**Appeal by Hallam Land against non-determination
of an outline planning application for up to 300 dwellings with all matters reserved except
access Land at Newark Road, Sutton-in-Ashfield**

Planning Inspectorate Reference: **APP/W3005/W/24/3350529**

Council Reference: **V/2022/0629**

Traffic queue from Newark Road stretching down Coxmoor Road and Hamilton Road. Photo taken from just off the MARR A617. Photo taken December 2024.

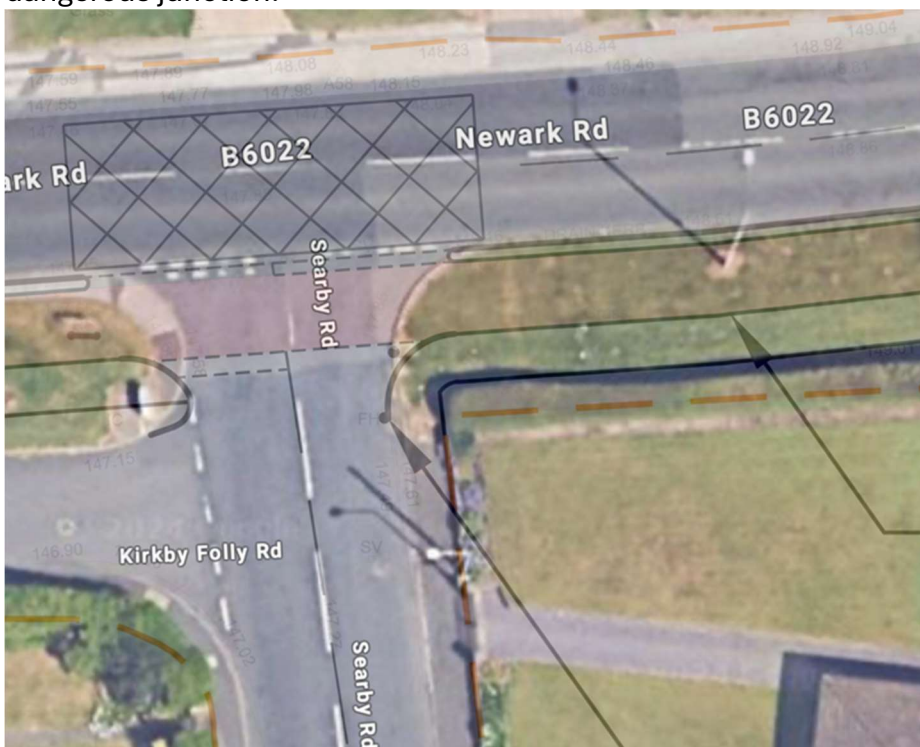
There is also the issue of the traffic queues created by the level crossing on Station Road/Newark Road. Unlike the automated crossing on Coxmoor Road that is only down for a matter of seconds prior to the passing of a train, the Newark Road crossing is manually operated from the control centre in Derby. This is due to Network Rail's perceived risk profile from the proximity of the crossing to the Newark Road/Station Road/Kirkby Folly Road junction. Despite multiple requests to Network Rail to review the timings of their closure of the gates it is the case that the gates are regularly shut between 4 and 10 minutes prior to the passing of a train. At peak times this regularly leads to traffic queues

stretching past the proposed development's new junction location. I regularly see queues stretching down Coxmoor Road and Hamilton Road all the way back to the MARR A617.

Given that residents on the proposed development would be so car dependent it is also clear that the proposed development would further worsen traffic at peak times due to the additional vehicle movements it would bring and the additional interruption in traffic flow brought by the proposed new junction. For such a car dependent development to be considered I feel it should bring forth solutions to the local traffic issues rather than exacerbating them.

This then overwhelms the capacity of the downstream drainage systems causing widespread flooding on Newark Road and the service road. Photos from Oct 2023.

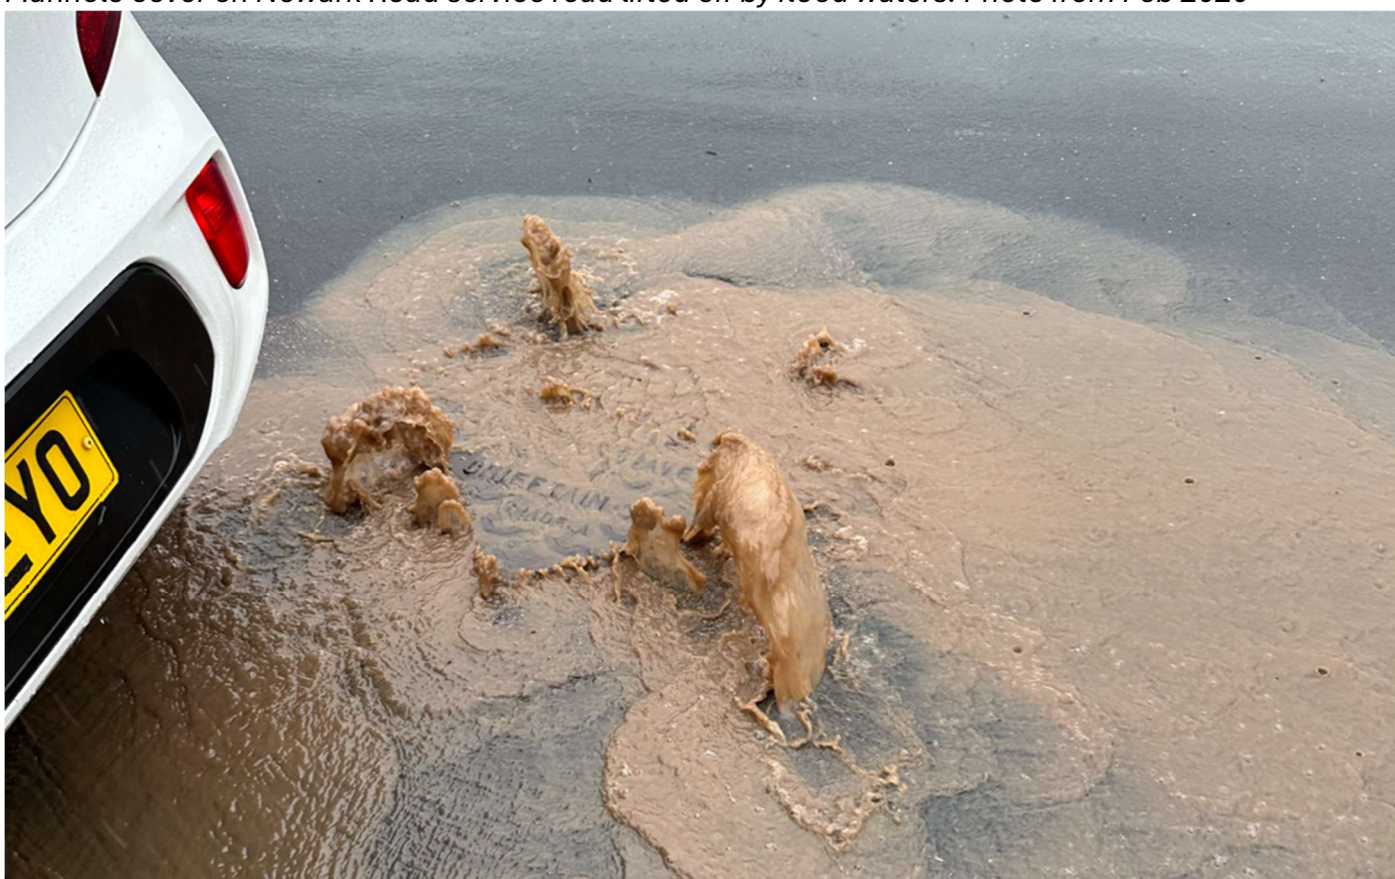
The Sutton Junction estate frequently suffers from flooding issues from the flow of water from the proposed site. While SUDS are there to mitigate the impacts of the development, I am concerned that the developer is not taking measures to protect the new development from flooding, nor using this development as an opportunity to invest in measures to alleviate the existing flooding issues in the area.

Much of the Sutton Junction Estate was built by different developers. Searby Road development was sold off piecemeal and different developers took different approaches to drainage. While much of the Sutton Junction Estate has separate surface and foul water drainage running down the street many properties on the estate have combined systems that empty only into the foul system. This already causes issue in flood situations with residents on the Newark Road service road and Cardinal Court having reported situations of manhole covers lifting off and dumping raw sewage onto their gardens. I am extremely concerned that the additional foul load the proposed development would place upon the local foul system would cause this situation to happen far more frequently in only more moderate rainfall situations. I do not see how this could be avoided without significant investment in expanding local drainage capacity.
